GOVERNMENT OF MANIPUR
PUBLIC HEALTH ENGINEERING DEPARTMENT

MINUTES OF THE PRE-BID MEETING FOR MANIPUR WATER SUPPLY PROJECT UNDER NDB HELD ON
10-01-2020 IN THE OFFICE CHAMBER OF CHIEF ENGINEER, PHED, MANIPUR
(This is issued as per Sectt.-PHE letter No. 8/23/2019-PHE dated 4th Feb, 2020)

Ref: NIT No. CE/PHE/3-94/NDB(W)/P-I/2019/2740, dated: 26/12/2019

TYPICAL SITE PLAN FOR EXISTING WATER SUPPLY SYSTEM

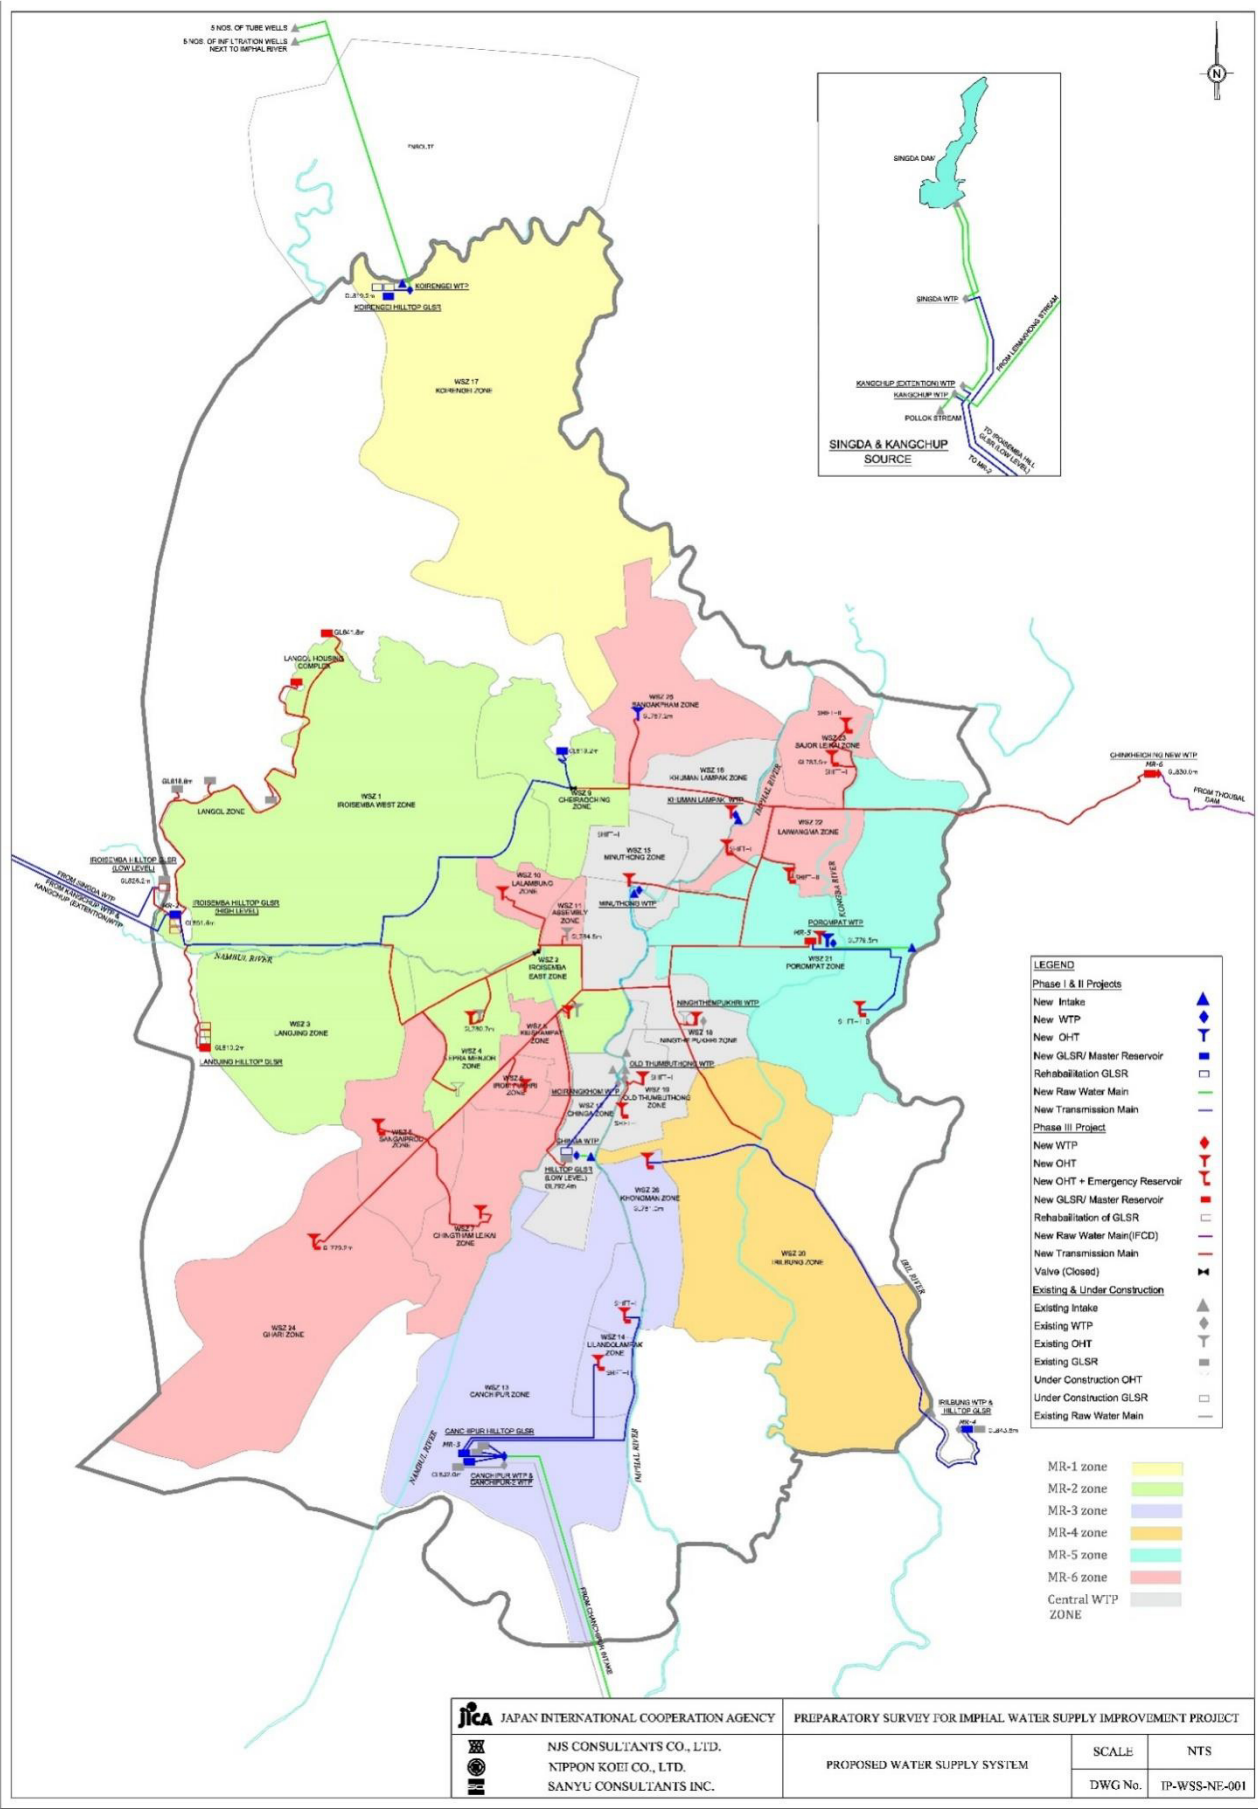
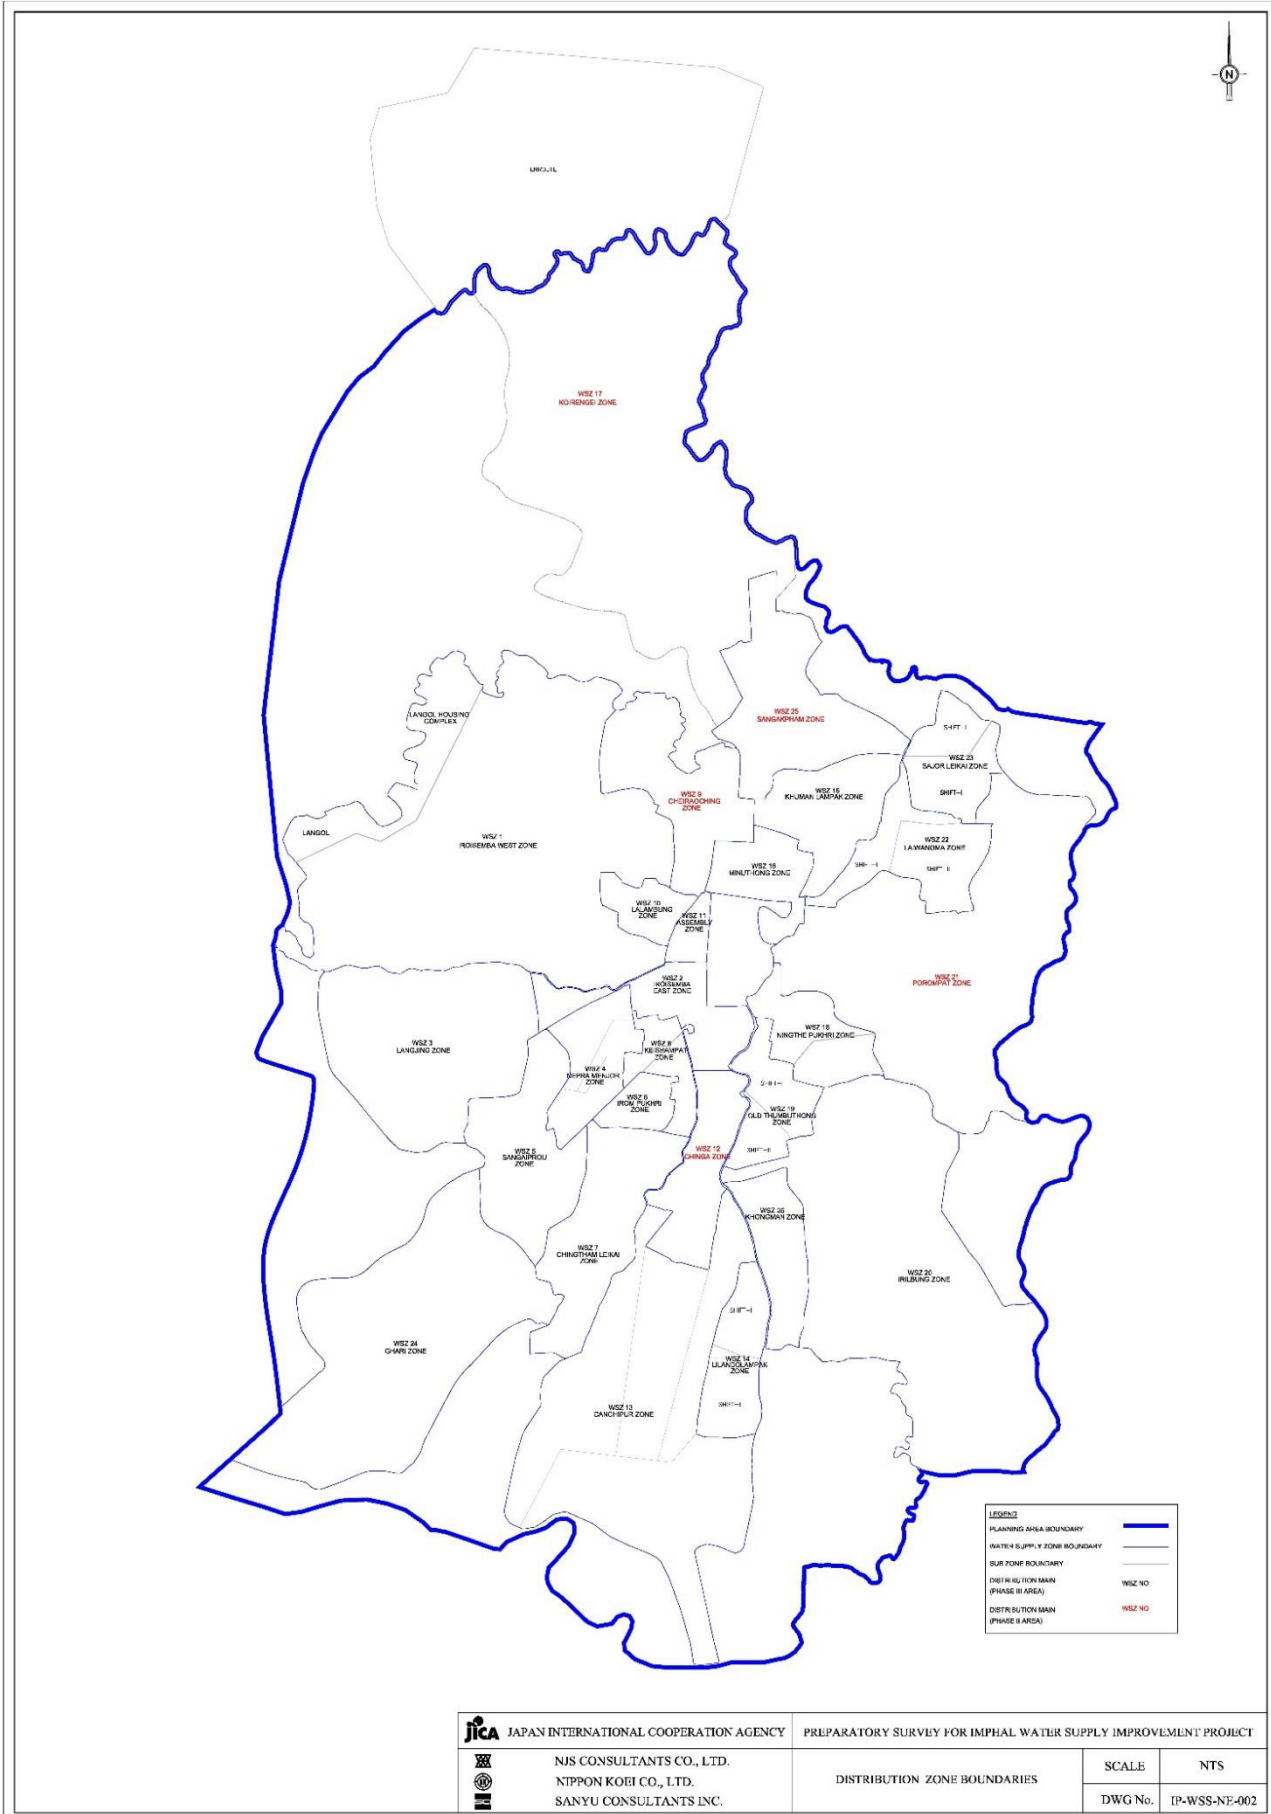
Page No. -			
	Para No/ Clause No.-S. No. 5.08			
73	Section No. - General	-	We presume that WTP shall be manually operated with manual valves/ Sluice gate. Kindly confirm.	Clarified as:- SCADA ready valves and sluice gates shall be provided.
	Page No. -			
	Para No/ Clause No. -			
74	Section No. - General	-	Kindly confirm, whether filter beds shall be covered or open to sky.	Clarified as:- Filter bed shall be designed as R.C.C covered structure.
	Page No. -			
	Para No/ Clause No. -			
75	Section No. - General	-	Kindly provide the detailed raw water quality analysis report to design the WTP.	Clarified as:- Water testing report is provided as Annexure-VI
	Page No. -			
	Para No/ Clause No. -			
76	Section No. - General	-	Kindly provide the WTP Plot contour diagram in CAD format to design the WTP.	Clarified as:- Typical site plan is provided as Annexure-VI
	Page No. -			
	Para No/ Clause No. -
